**RFT 26-085 Interior Renovations and Elevator Addition - King's Road PS**

**The following, issued by the Halton District School Board (HDSB) September 2, 2026, shall be incorporated in the specifications and shall form part of the proposal document for the above.**

1. Bidders are asked to review the attached Addendum # 1 as drafted by WK Lim Architects Inc. (195 pages).
2. **REVISED FORM OF TENDER:**
  - a. Bidders are asked to review the attached Revised Form of Tender. All bids must be submitted using the attached Revised Form of Tender (2 pages).

1 SITE  
- PLAN

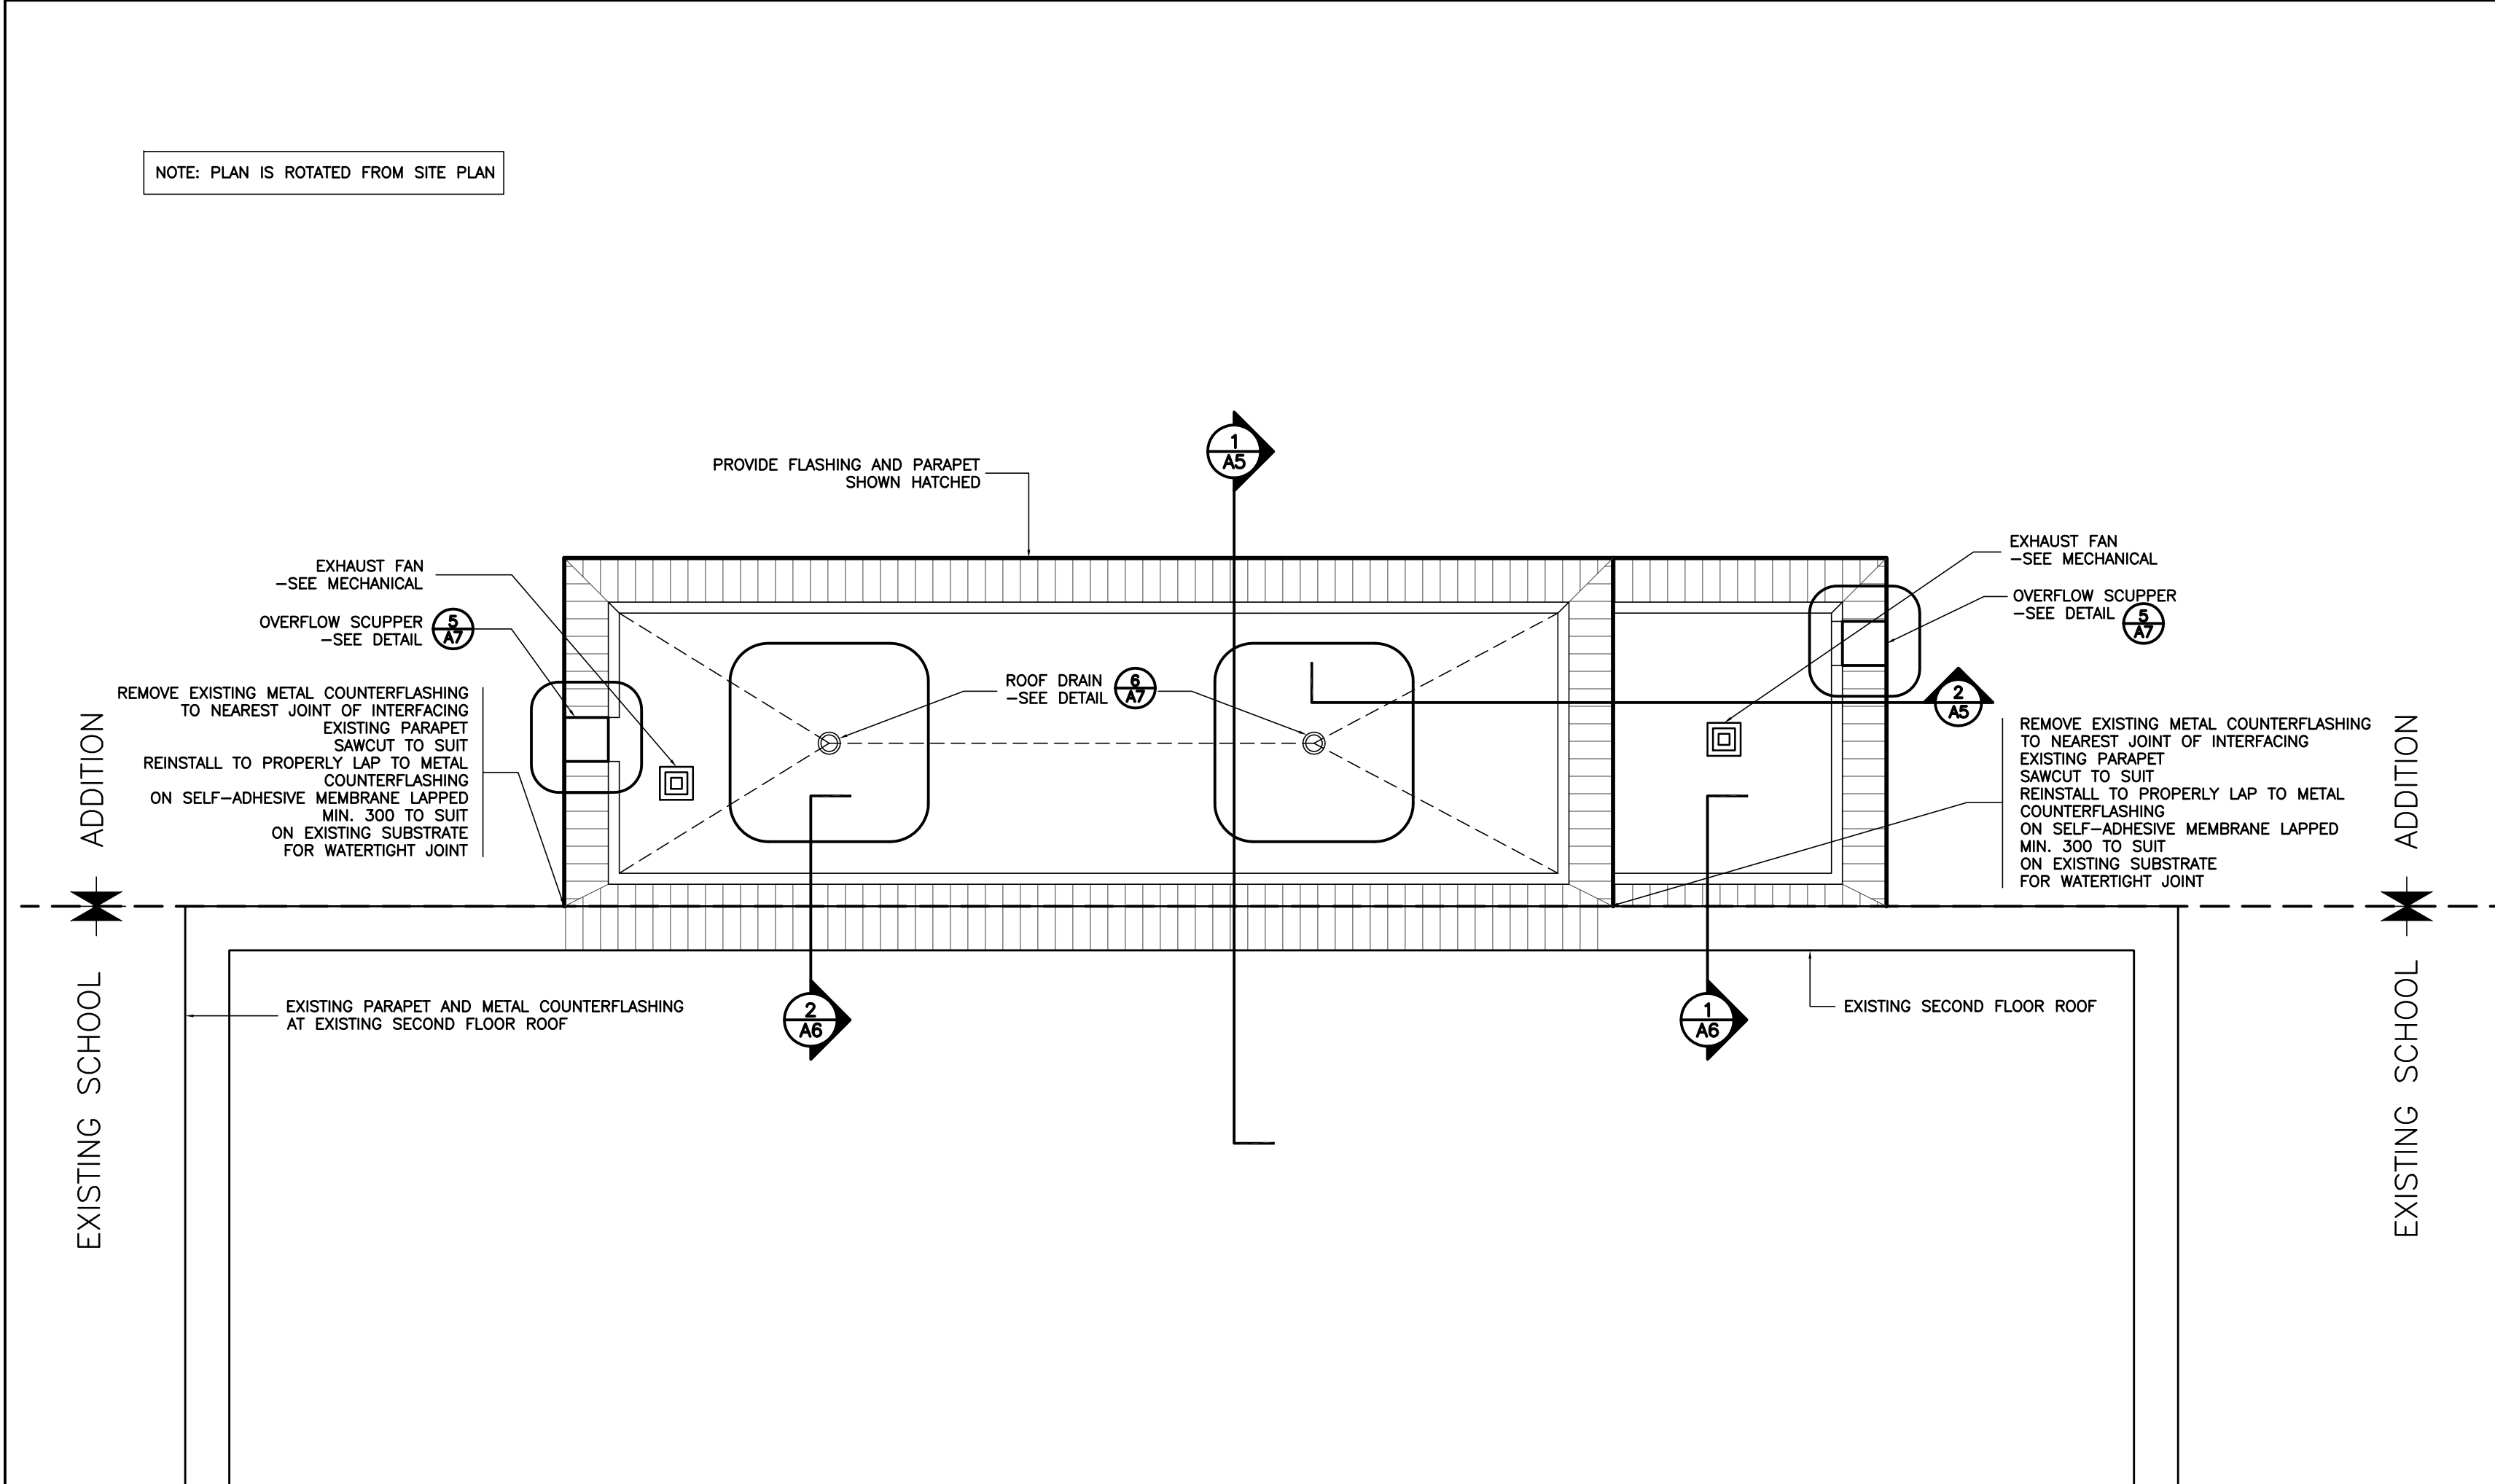
ITEM 3: SITE PLAN REVISIONS  
REFERENCE: Drawing SP1 Detail 1 revised August 31, 2026 (attached)

Description: For site access, construction hoarding, staging, and delivery routes, refer to Drawing SP1 Detail 1, revised August 31, 2026 (attached).

2 ASPHALT  
SP1 DETAIL

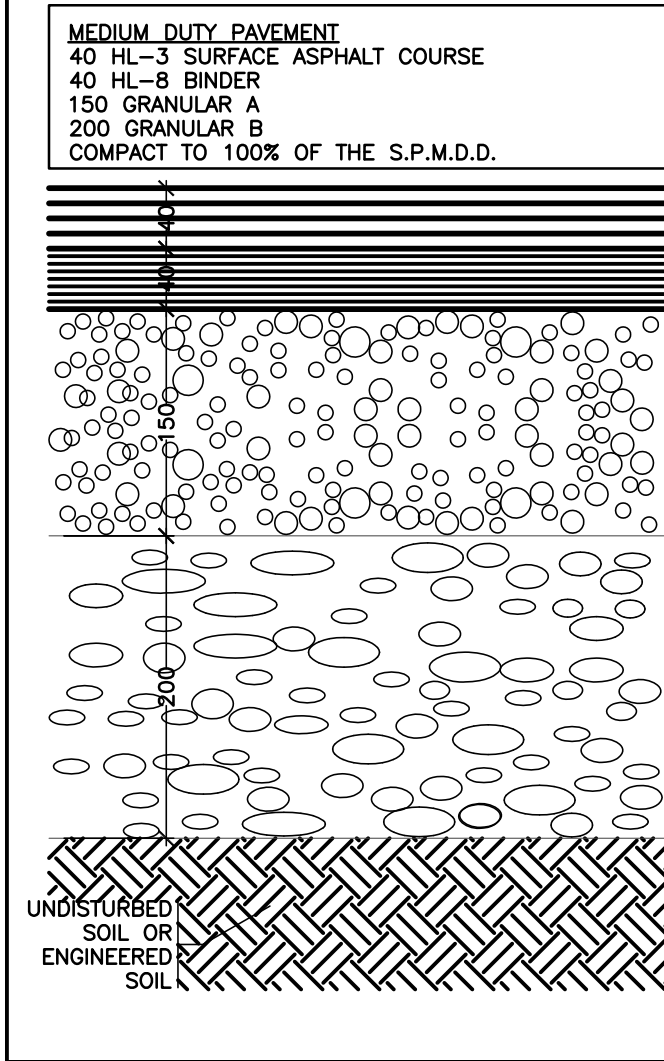
Please advise if we should follow the asphalt detail on SP-2 (HL8 40mm) or the specifications (HL8 50mm and HL3 40mm)?

ASPHALT REVISIONS  
Specifications Section 02513  
Drawing SP2 Detail 2 revised August 31, 2026 (attached)

At Specifications Section 02513, revise Article 3.10.1 from:  
“.1 Specified granular and pavement thicknesses are as shown on drawings and no less than as follows below:  
.1 40 mm HL 3 Surface  
.2 50 mm HL 8 Binder  
.3 150 mm Granular A  
.4 300 mm Granular B Type I”  
To:  
“.1 Specified granular and pavement thicknesses are as shown on drawings and no less than as follows below:  
.1 40 mm HL 3 Surface  
.2 40 mm HL 8 Binder  
.3 150 mm Granular A  
.4 200 mm Granular B Type I”

Refer to Drawing SP2 Detail 2 revised August 31, 2026 (attached).

**1**  
**A1** ADDITION GROUND FLOOR  
ENLARGED PLAN

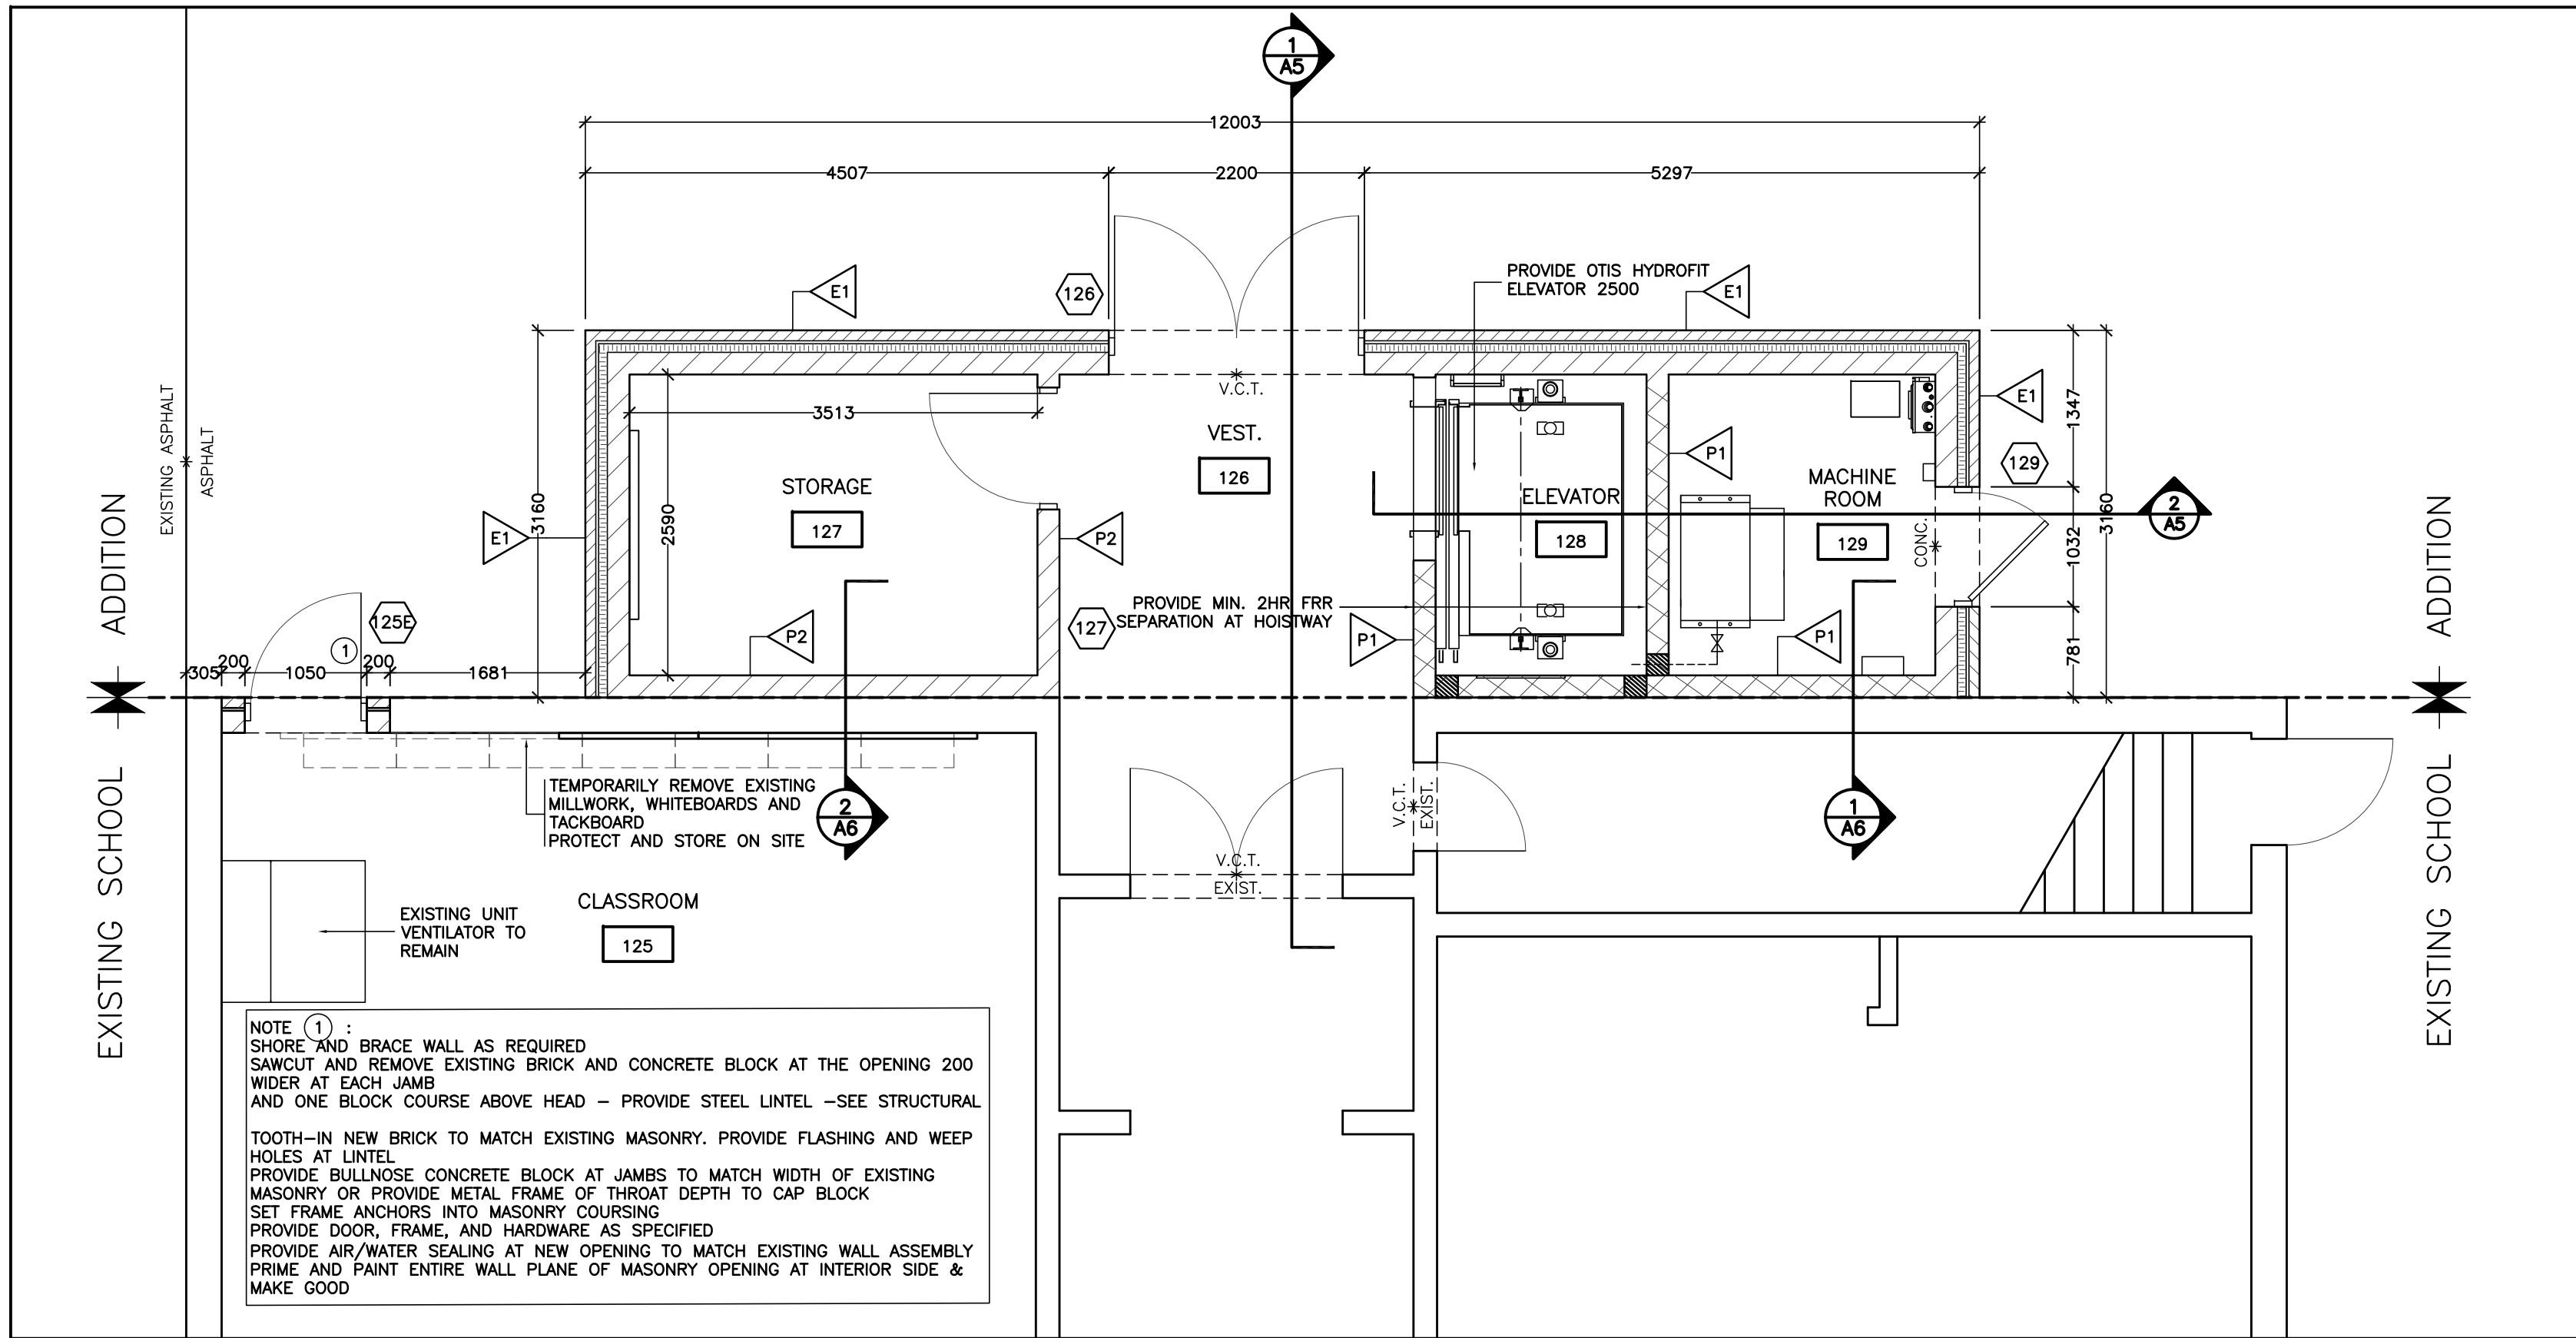
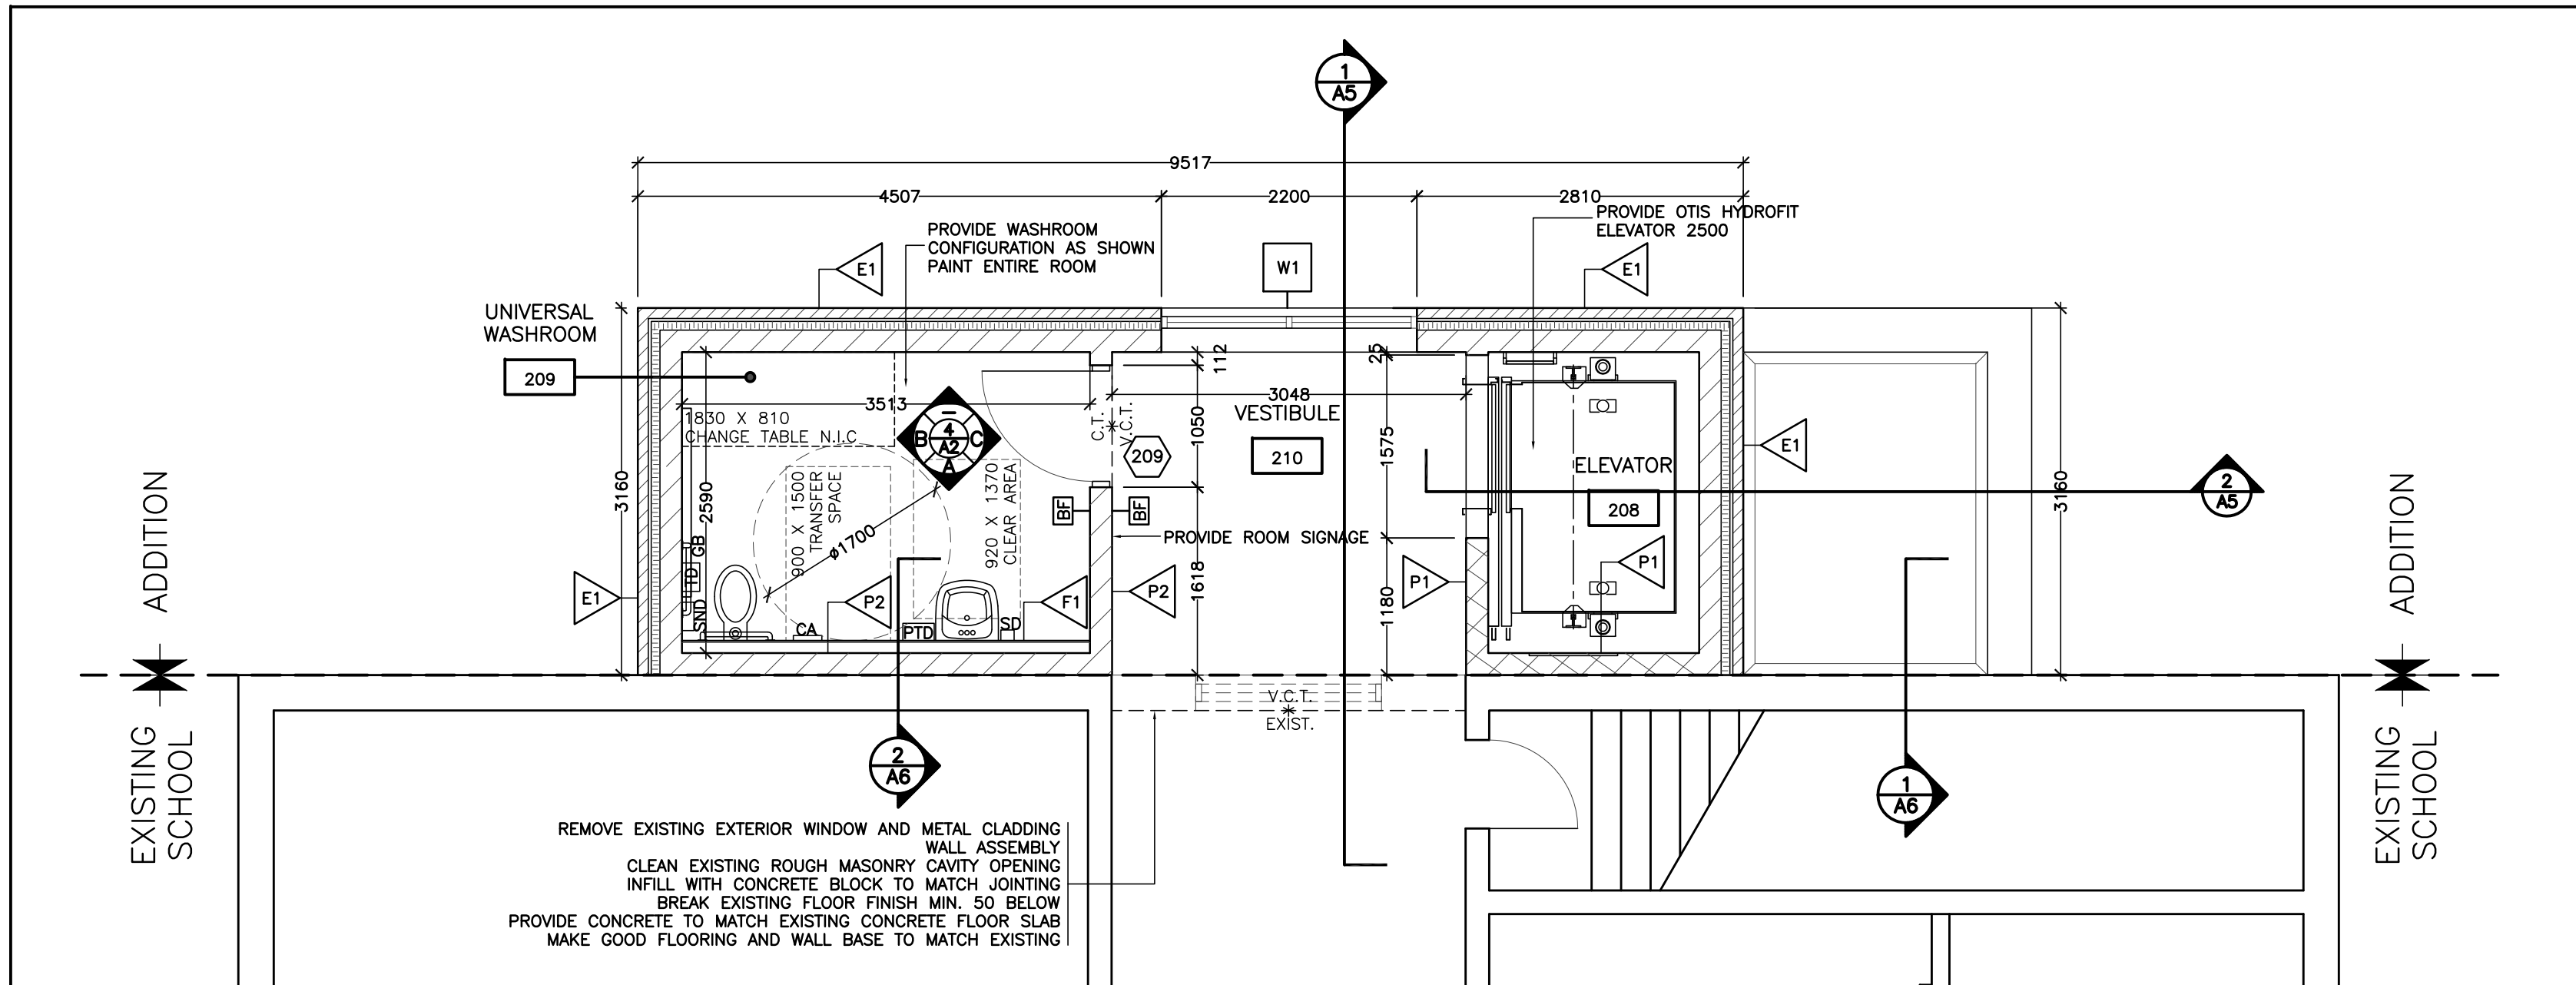
ITEM 1: PROJECT PHASING  
REFERENCE: Drawing A1 revised August 31, 2026 (attached)  
Specifications Section 01011 revised August 2026 (attached)

Description: For the revised phasing of the scope of work, refer to Drawing A1, Details 1 and 2, revised August 31, 2026, and Specification Section 01011, revised August 2026. (attached)
